<b>Licence Number</b>	L8308/2008/2
<b>Licensee</b>	CITIC Pacific Mining Management Pty Ltd
<b>ACN</b>	119 578 371
<b>Registered business address</b>	45 St Georges Terrace PERTH WA 6000
<b>Date of amendment</b>	9 June 2017
<b>Prescribed Premises</b>	Category 5: Processing or beneficiation of metallic or non-metallic ore Category 6: Mine dewatering discharge Category 12: Screening, etc. of material Category 52: Electric power generation Category 54: Sewage facility Category 57: Used tyre storage (general) Category 64: Class II putrescible landfill site Category 73: Bulk storage of chemicals, etc.
<b>Premises</b>	Sino Iron Project Mine Site Mining Tenements M08/123, M08/124, M08/125, M08/264, M08/265, M08/266, G08/54 and L08/126 MARDIE WA 6714

### Amendment

## Amendment Notice

## Amendment Description

Figure 3: TSF monitoring bores

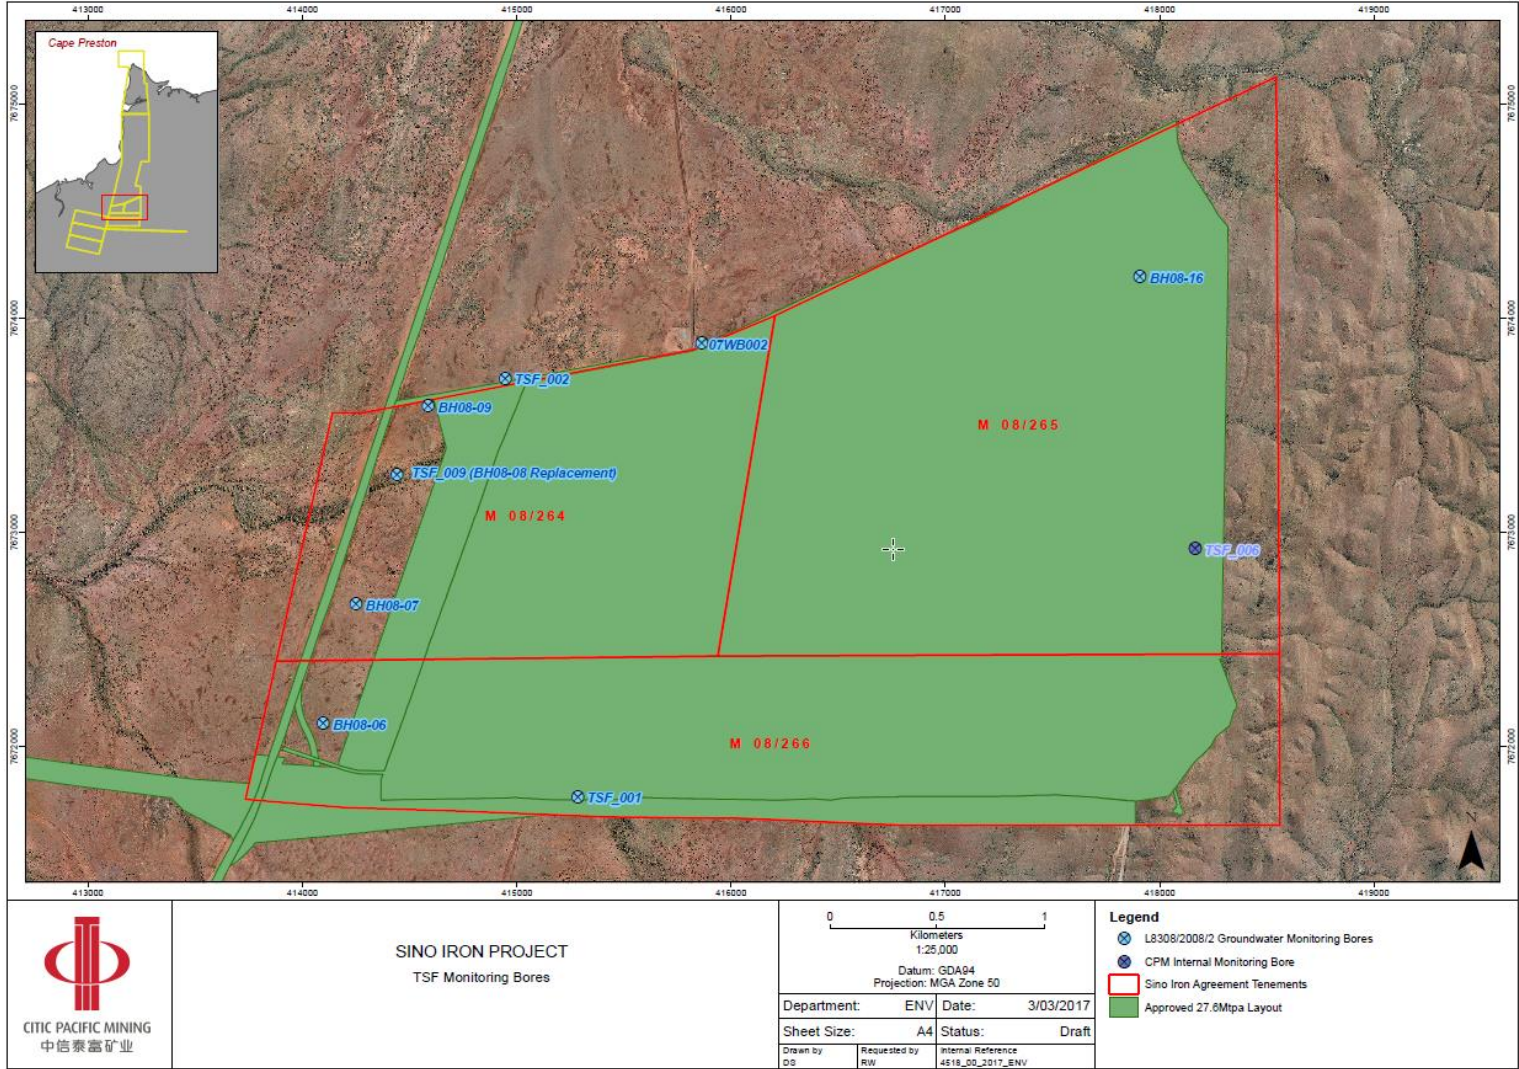
On 3 March 2017 DER was further advised that groundwater monitoring bore BH08-16 was damaged during earthworks for TSF2 and a replacement bore is required. As a drill-rig is necessary to be mobilised to site to drill the replacement bore, it may be a number of months before a sample can be taken. The Licensee will take interim samples from TSF\_006, an internal bore that is in the vicinity of BH08-16 as shown in Figure 3 below until the replacement bore is in place.

Bore BH08-08 has been removed and replaced by TSF\_009, and bore BH08-16 has been removed from Condition 3.7.1, Table 3.7.1.

Improvement Program Condition 4.1.1 has been updated to include IR2 for replacement of groundwater monitoring bore BH08-16.

11. Replacement of the *Premises map, map of containment infrastructure and map of monitoring locations* to the following:

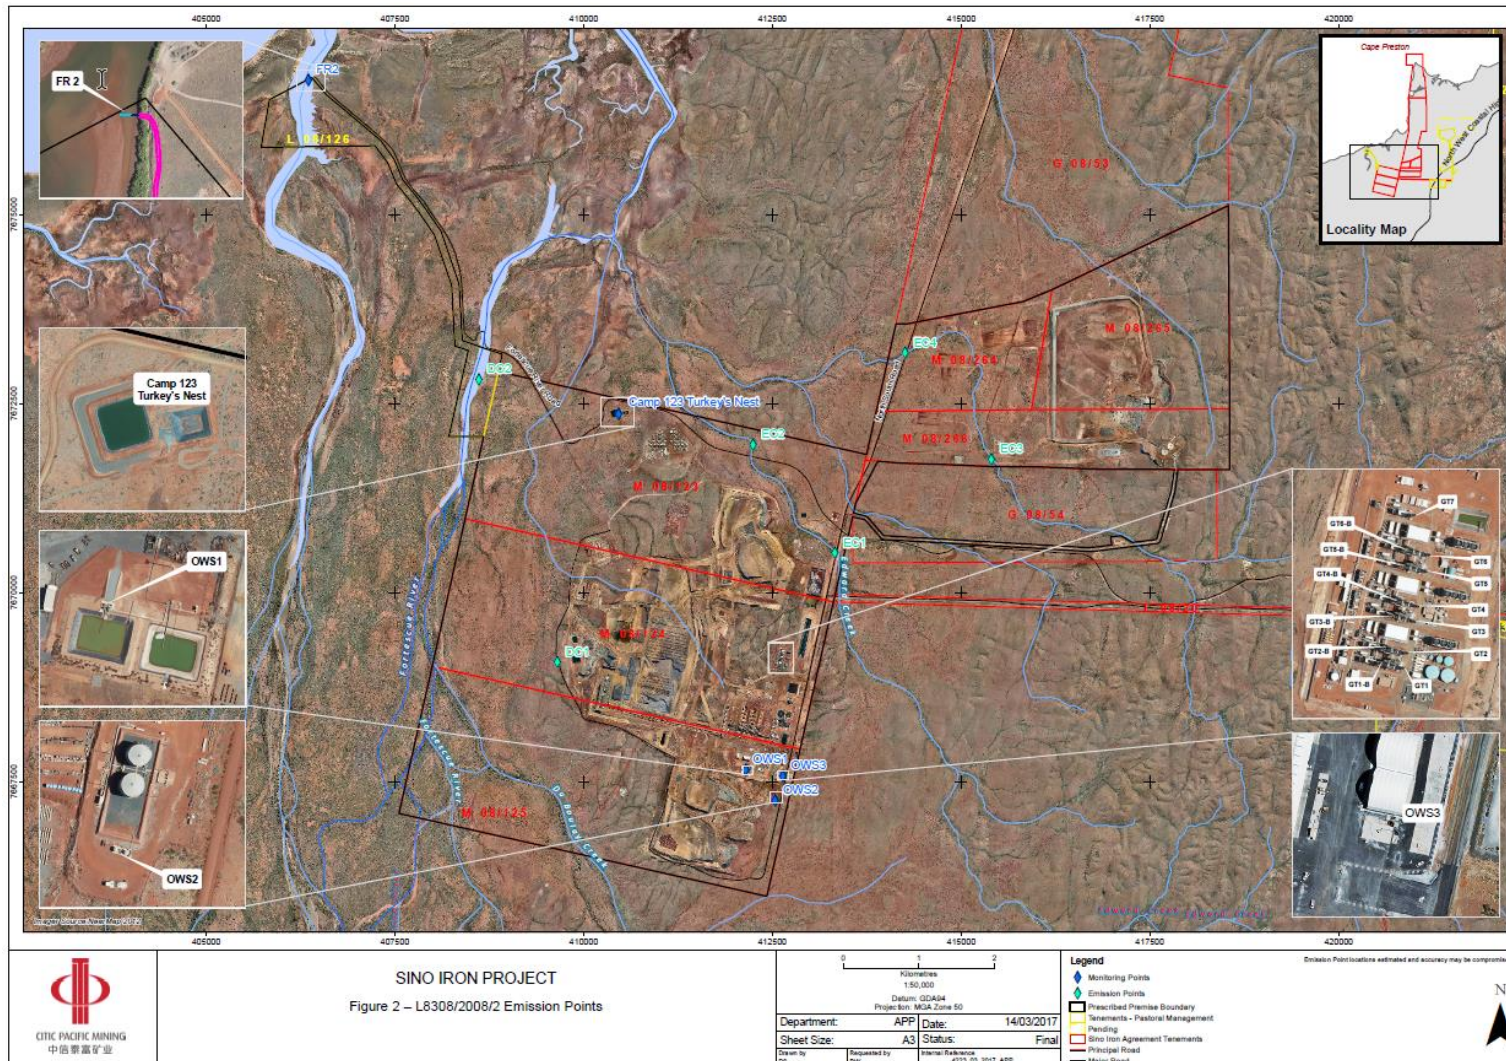
The Premises is shown in the map below. The black line depicts the Premises boundary.  
 The location of the containment infrastructure defined in Table 1.2.3 is shown below.  
 The locations of the emission point defined in Table 2.3.1 is shown below.  
 The location of the monitoring points defined in Tables 3.4.1, 3.5.1 and 3.7.1 are shown below.

12. Replacement of the first map of *Map of emission and monitoring points* to the following:

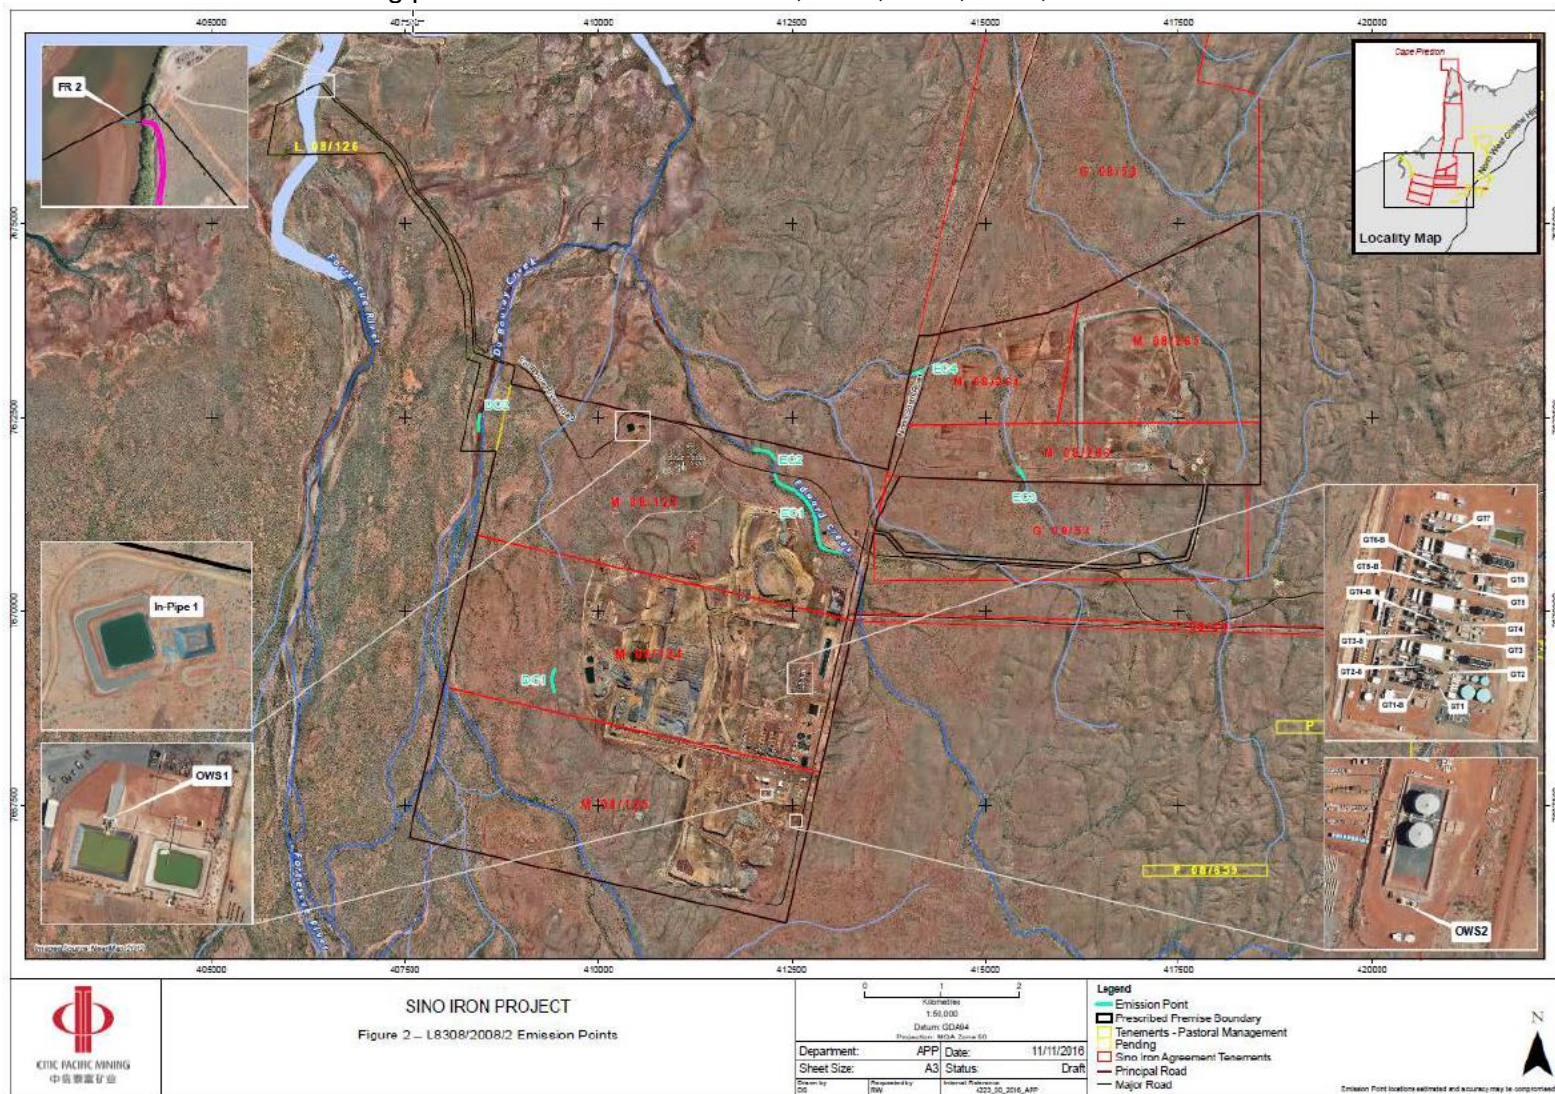
The locations of the emission points defined in Tables 2.1.1 and 2.2.1 are shown below.
